**ADDENDUM
NO. 4**

**Greenfield Central High School Auditorium Renovation and
Addition – Bid Package No. 1
810 N. Broadway
Greenfield, IN 46140**

ADDENDUM NO. FOUR

1 LOW ROOF AND FLOOR FRAMING PLAN - UNIT L
 3/32" = 1'-0"
 NOTE: T&STEEL = +16'-10 3/8" U.N.O.

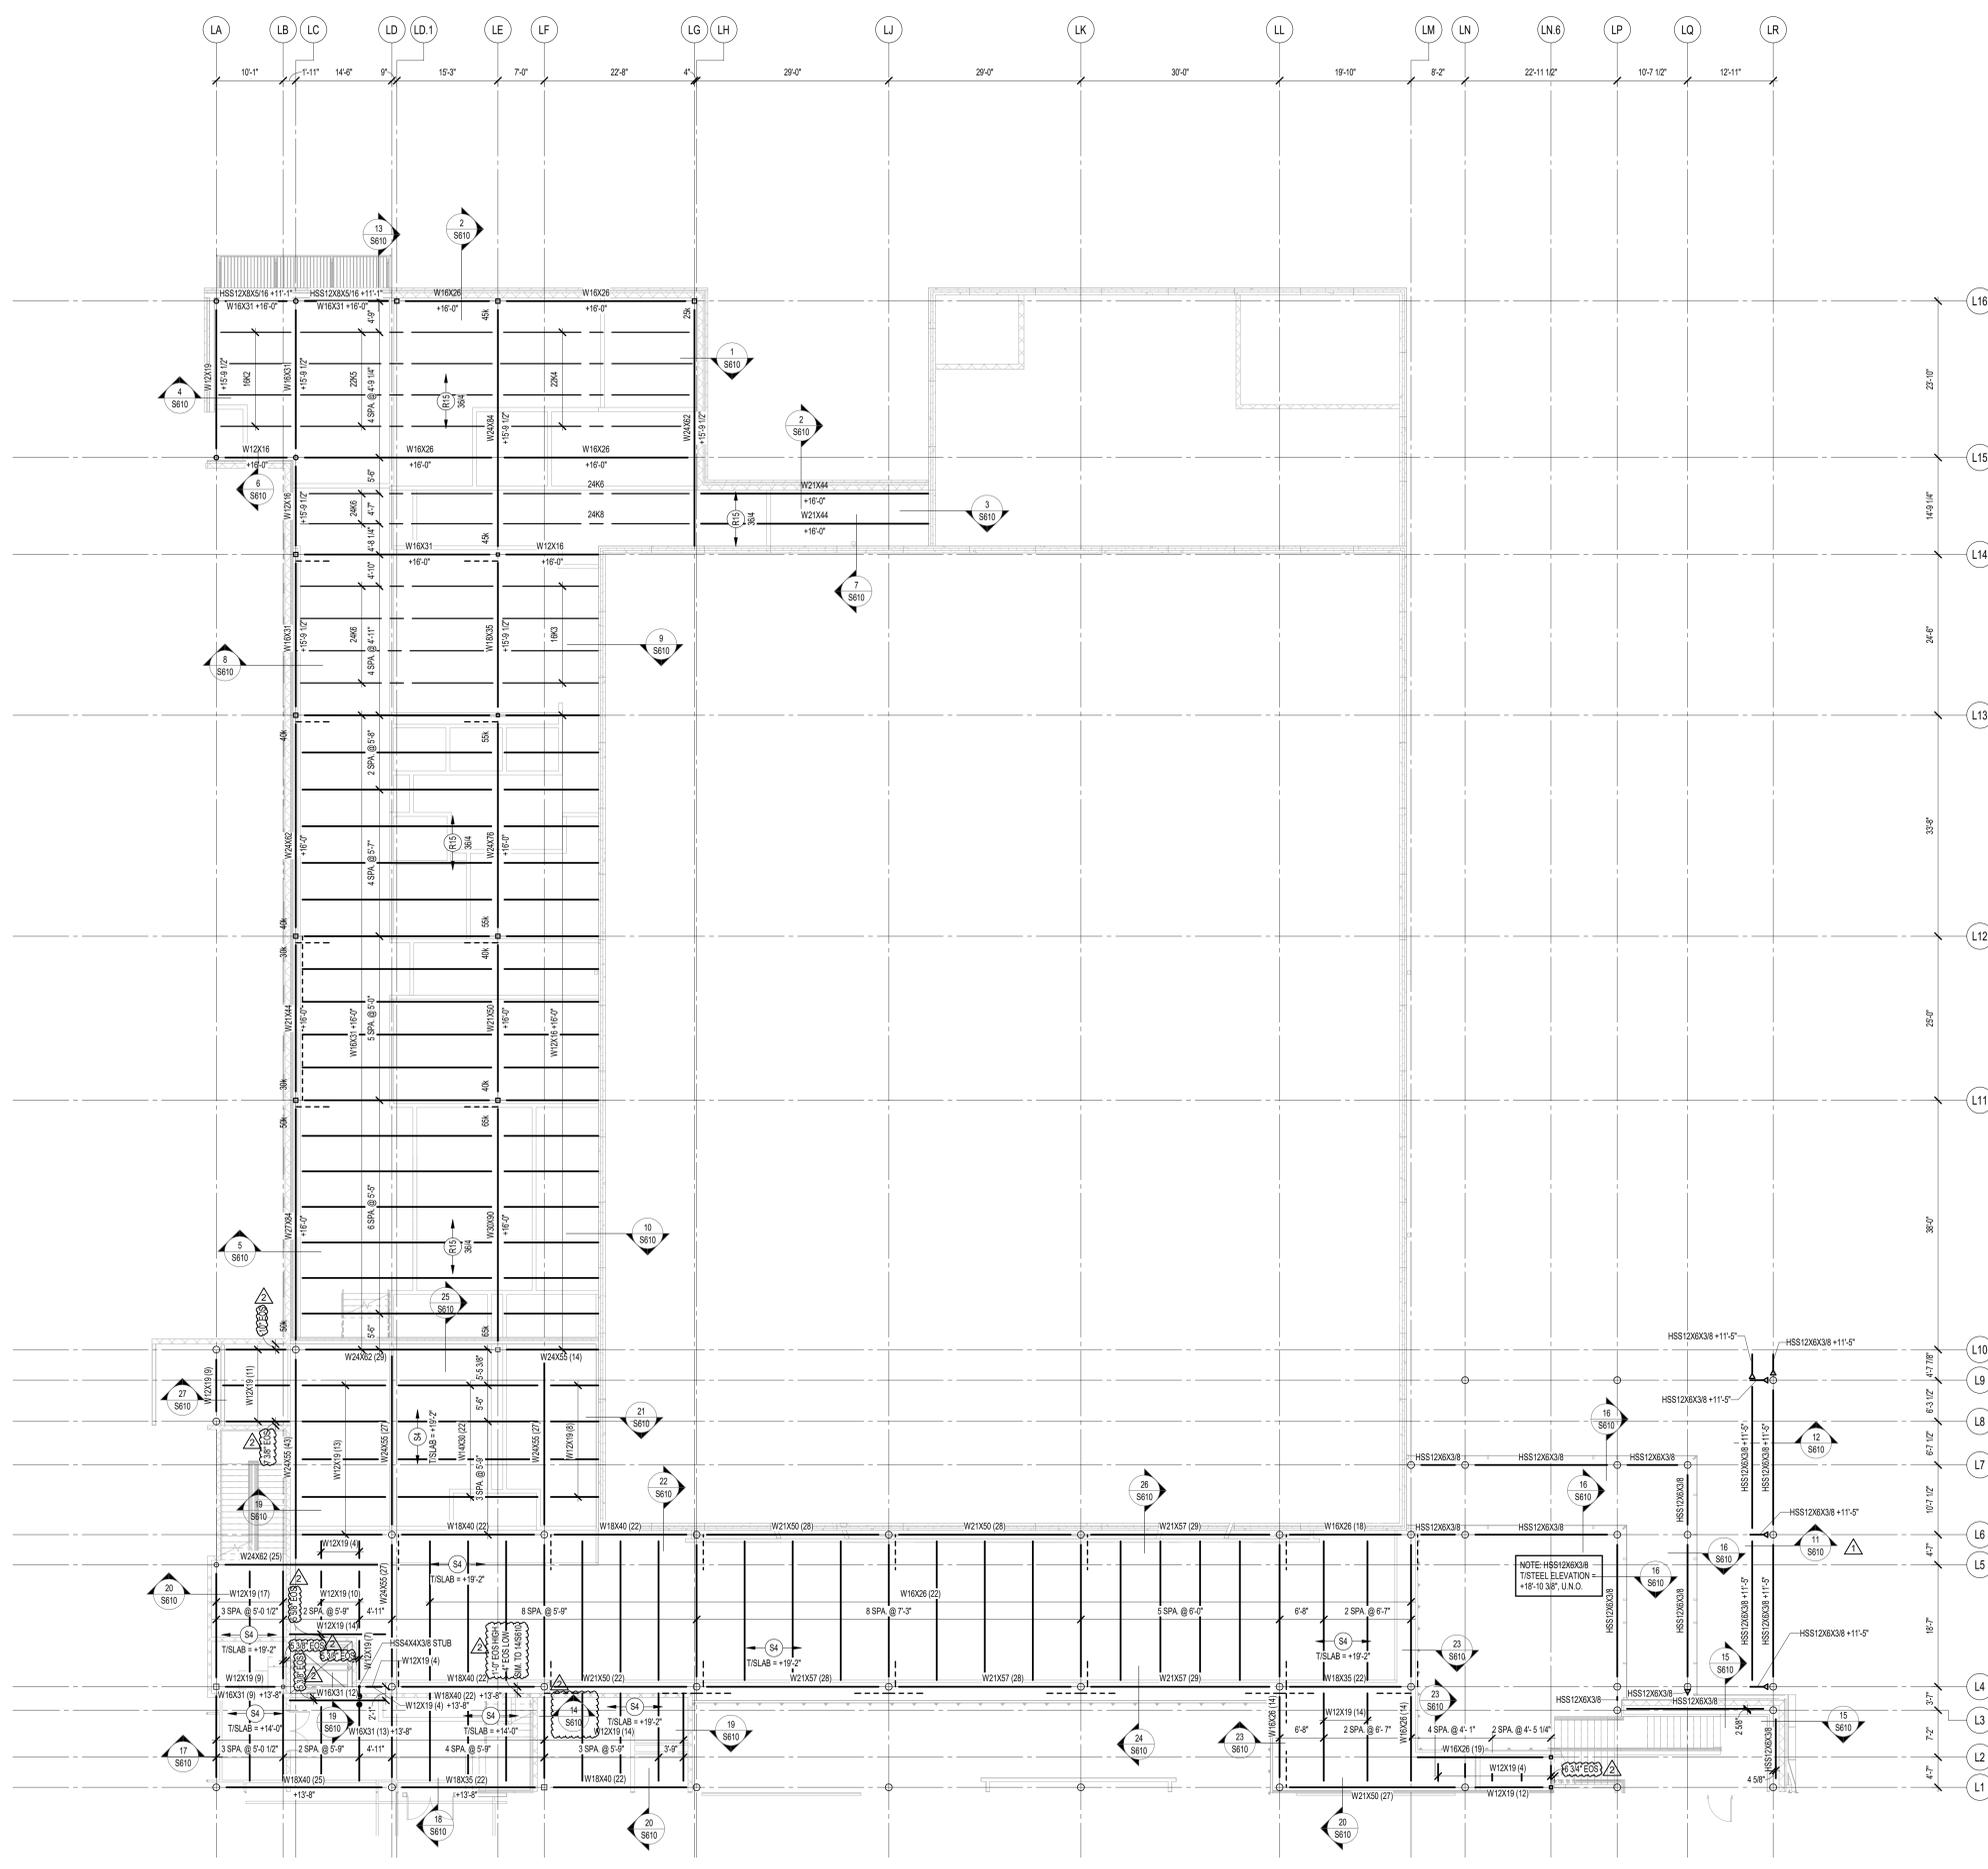
2. S101L – FOUNDATION PLAN – UNIT L
 - a. ADDED SOME DIMENSIONS
3. S102L – LOW ROOF AND FLOOR FRAMING PLAN – UNIT L
 - a. ADDED 14/S610 CUT ON PLAN
 - b. ADDED SLAB EDGE DIMENSIONS

1 MID ROOFS FRAMING PLAN - UNIT L
 3/32" = 1'-0"
 NOTE: 1/32" = 1'-0" U.N.O.

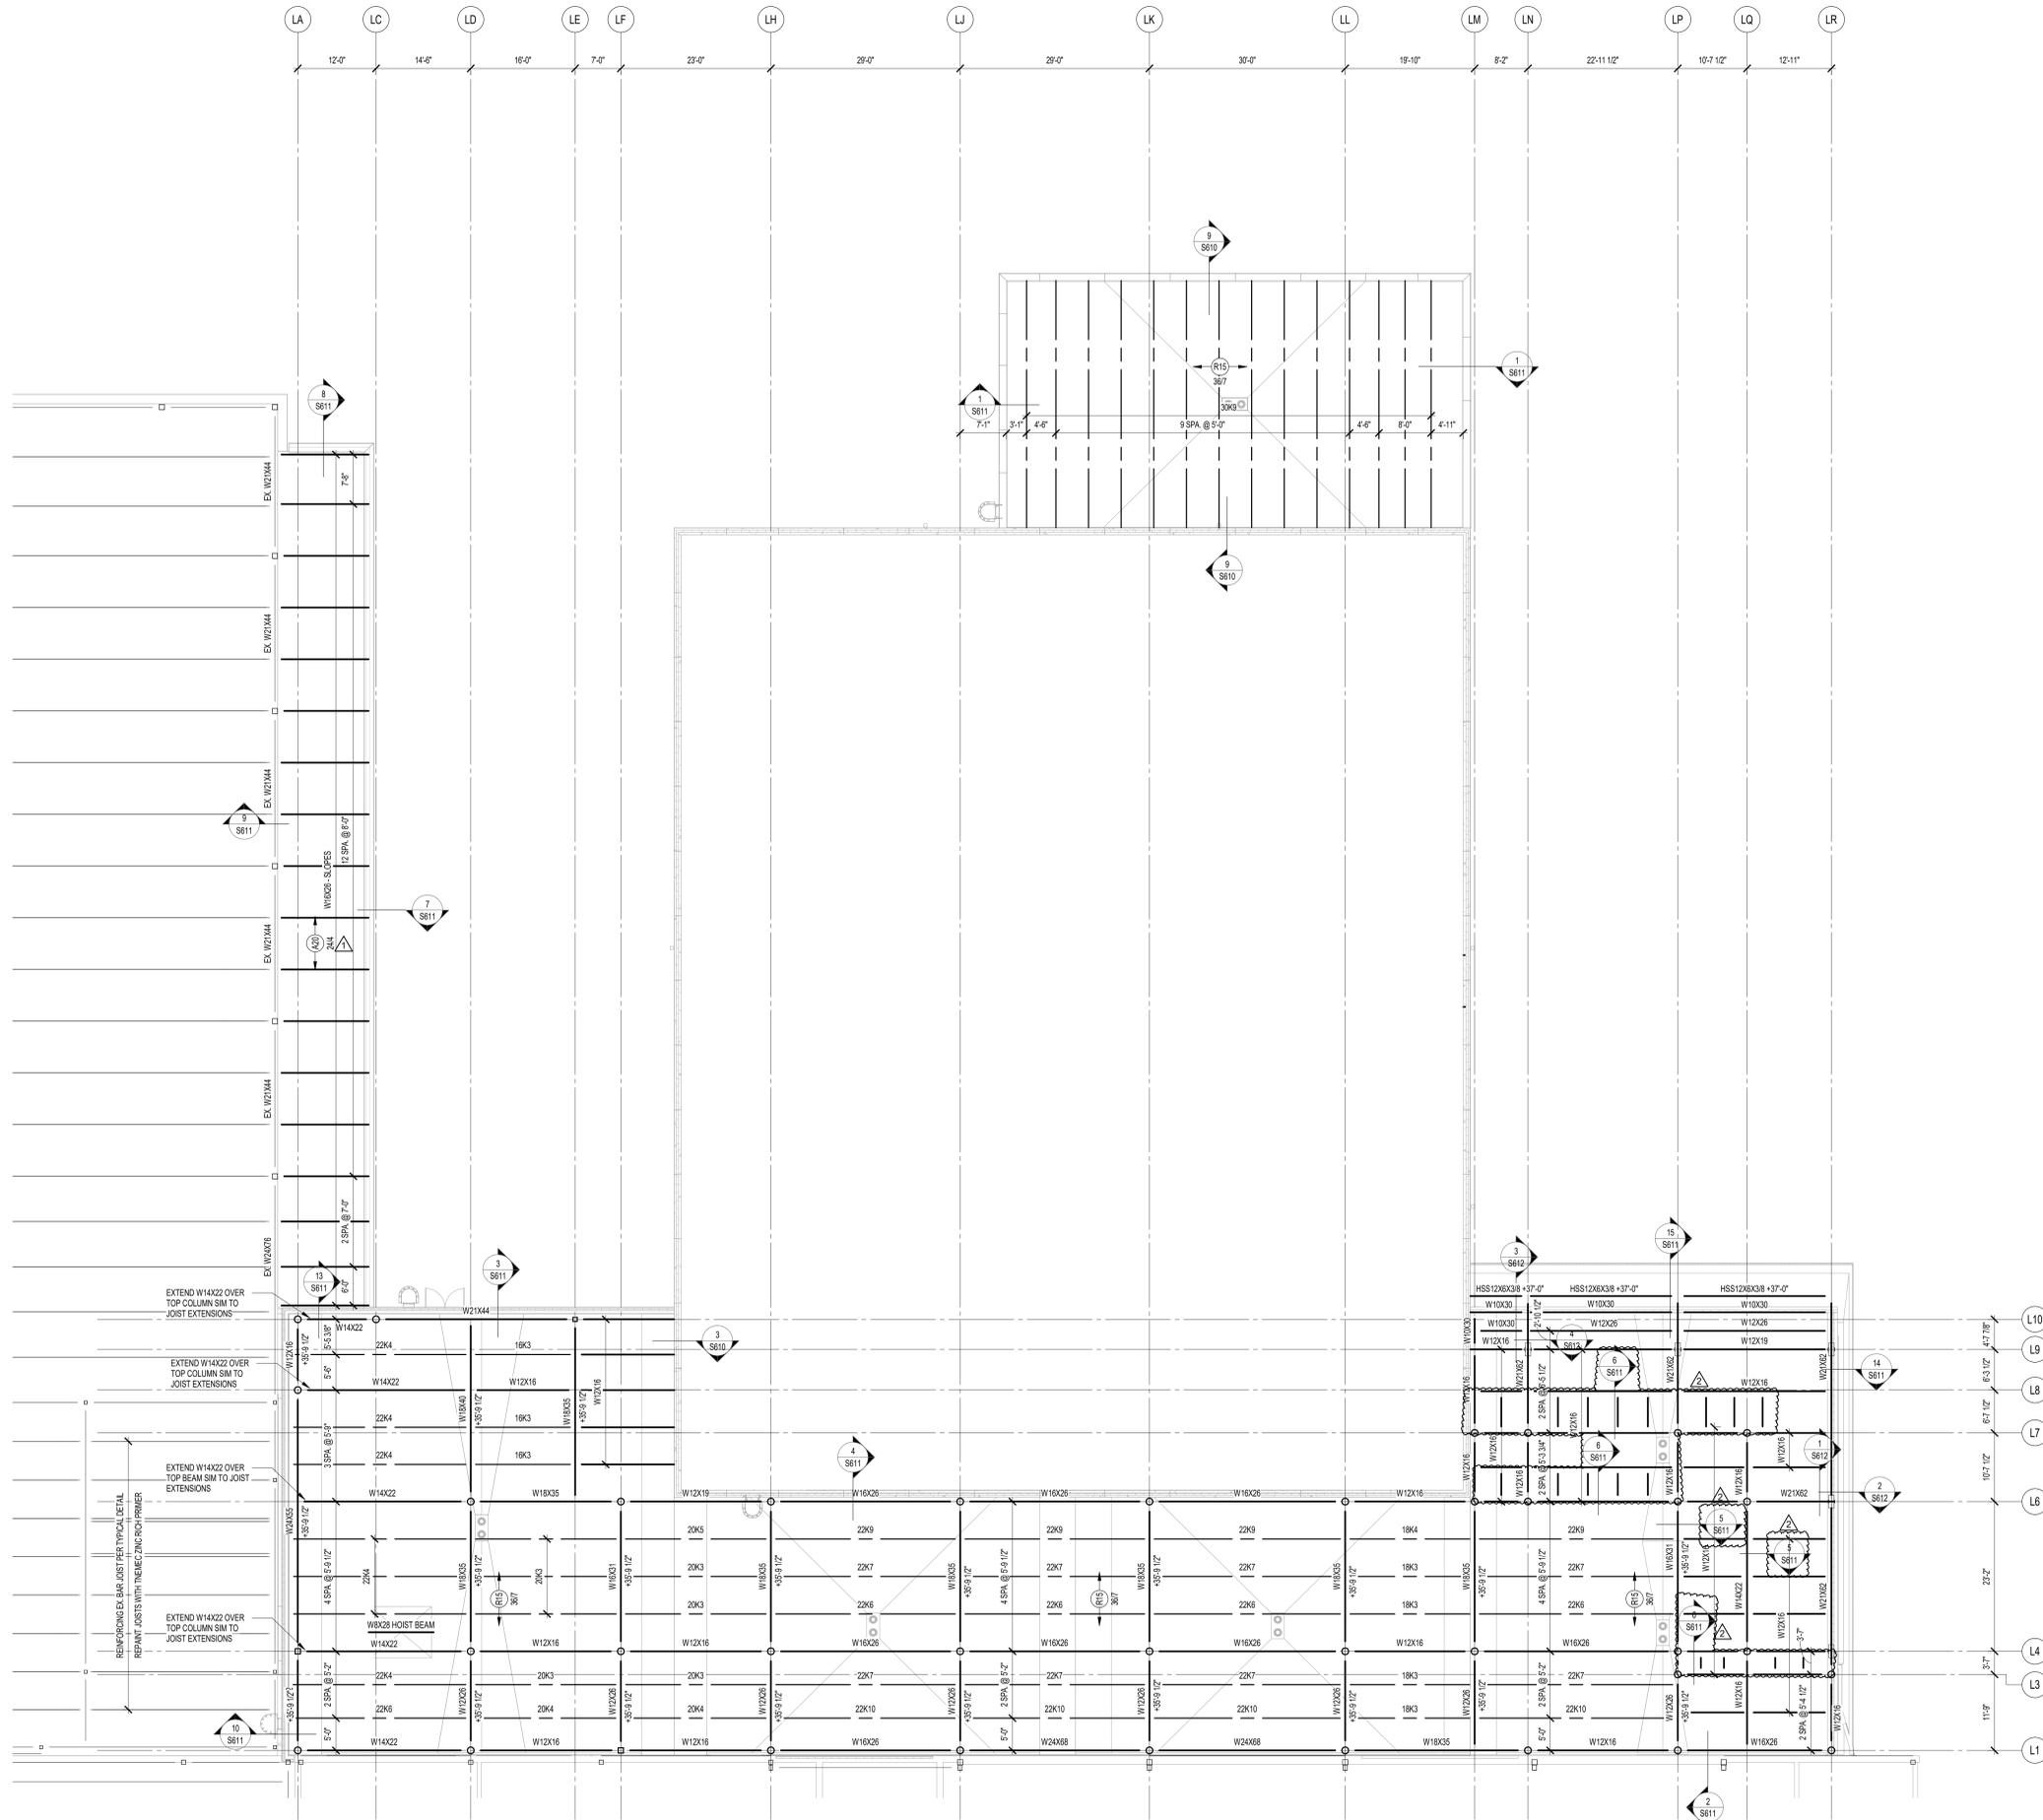
4. S103L – MID ROOFS FRAMING PLAN – UNIT L
 - a. ADD 5 & 6 ON S611 FOR CURTAIN WALL HEAD SUPPORT
5. S201 – ENLARGED AUDITORIUM FOUNDATION PLAN
 - a. ADDED M15 MAT FOUNDATION DIMENSION PLAN
